Comments to the Texas Commission on Environmental Quality Texas Pollutant Discharge Elimination System (TPDES) Permit No. WQ0015688001

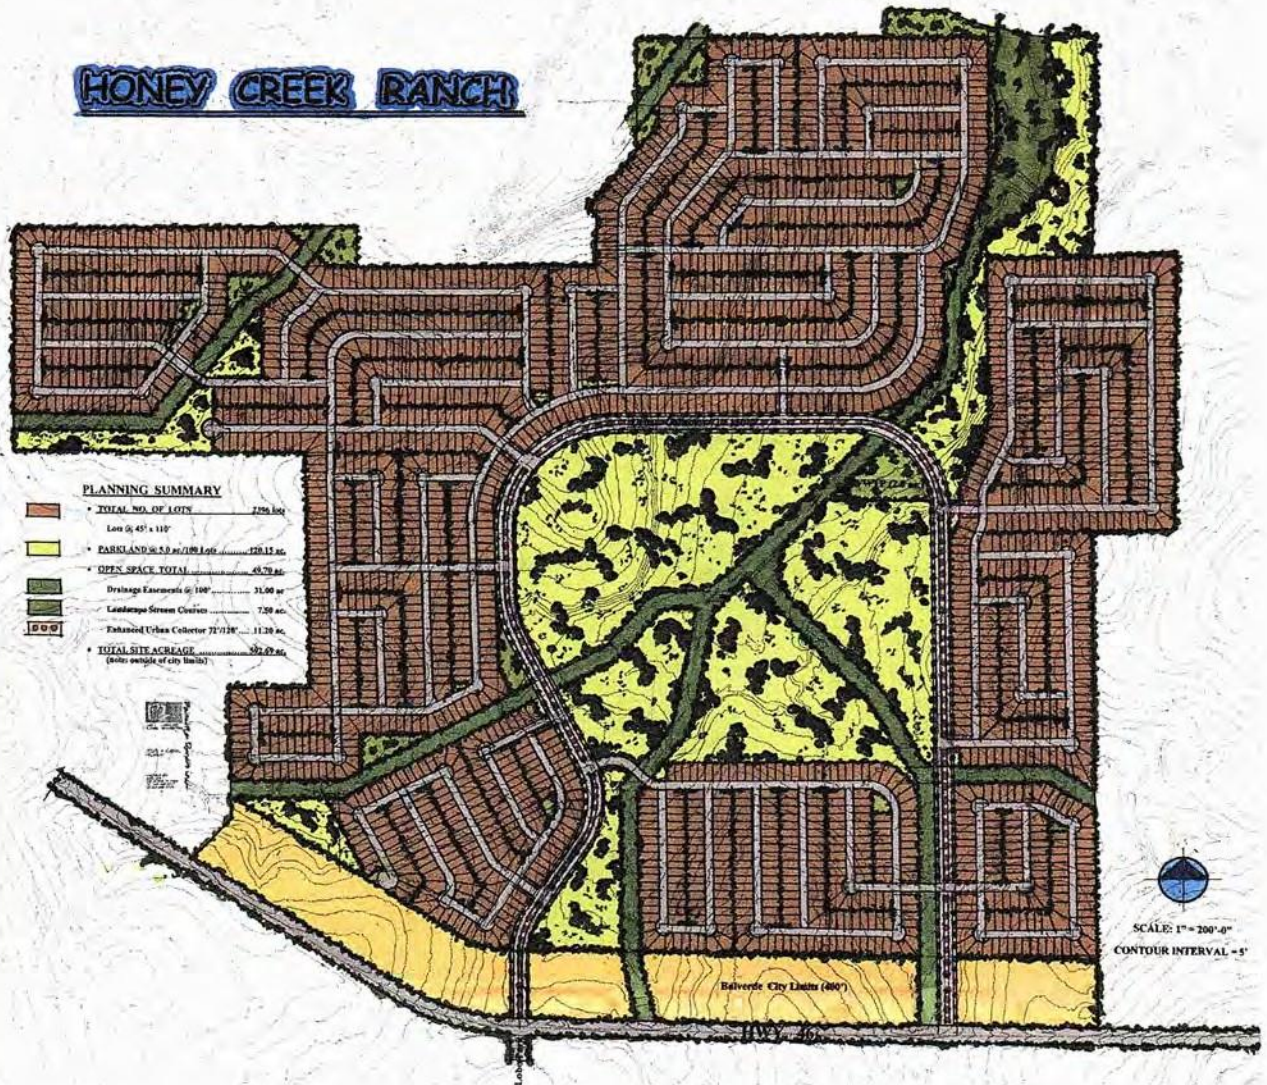
Regarding the idea that the proposed wastewater system would be implemented and run in a manner that would route the water resource to beneficial irrigation of “lawns and landscapes” rather than being discharged, the nature of the proposed land plan must be examined. What we see is a layout much more relevant to an area with gentle relief within an urbanized area, with densely-packed small lots laid over the area without much apparent consideration of the landforms, other than to provide for drainage easements. While the business aspects of this are indeed the business of Silesia Properties – it appears that the aim is to maximize lot yield without much regard to the character of the area – what we see does bear on how realistic it would be to accomplish much beneficial reuse.

Per the graphic showing the development plan – see above – it is proposed to place 2,396 lots on this land. The proposed design flow rate to be permitted is 500,000 gallons/day. The statutory design hydraulic application rate onto a subsurface drip field is 0.1 gallons/sq. ft./day, so this implies that there would need to be at least 5,000,000 sq. ft. of drip field area. (Note that if it were proposed to spray this water over the irrigated areas instead, the required area would be greater, and even then the instances of discharge would be “frequent” unless a large storage volume were to be provided, which would be rather costly.) That implies there would need to be an average irrigated area per lot of $5,000,000/2,396 = 2,087$ sq. ft. With the lots being only 45 feet wide, and presumably needing to accommodate about a 20-foot wide driveway, there would be precious little area in the front yards and parkways to provide this irrigated area, *way short* of the needed area.

So it is called to question where any beneficially irrigated area would be on this project. Other than drainage channels, which will not provide any area appropriate for this irrigation, there is no dedicated green space within the neighborhoods. The vast majority of the open space on this land plan is the large “central park”. The function of that area is entirely undefined, so the prospects for any irrigation within that area to be “beneficial” is entirely opaque at this point. Thus, the actual prospects for actually reusing, instead of discharging, the effluent remains entirely opaque. The assertion of the developer’s representative reported in The Rivard Report is entirely without any rational substantiation.
